Water entry at sliding sunroof

Topic number	LI77.20-P-073486
Version	1
Function group	77.20 - Electric sliding roof
Date	8/17/21
Validity	Model 463 as of model year 2019 (as of code XZ8) and sliding sunroof (code F15)
Reason for change

Attachments	
File	Description
Picture 2 - Swap hoses left vehicle side.JPG	Picture 2 - Rework instruction for left side

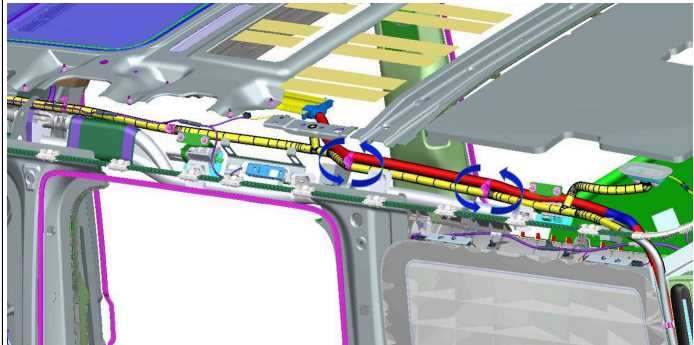
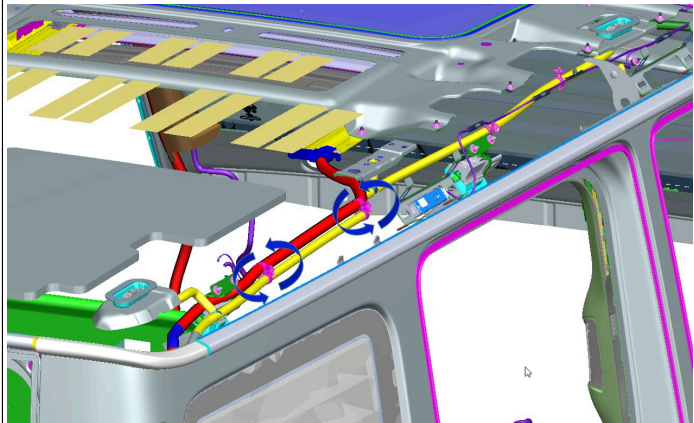
The left rear and right rear water drain hoses on the sliding sunroof frame may be incorrectly routed, with the result that water cannot drain properly due to the lack of a slope.

Water may accumulate at the rear of the sliding sunroof frame (see Picture 1) and subsequently overflow, causing water to enter through the roof lining.

- Route the left rear and right rear drain hoses of the sliding sunroof frame from the upper clip-on point to the lower clip-on point.

- This must be carried out for both fastening points at the C-pillar and D-pillar. Carry out this step on both the left and right side of the vehicle.

- Then move the water drain hoses of the roof luggage rack mounts from the lower clip-on point to the upper clip-on point (see Pictures 2 and 3, Video 1).
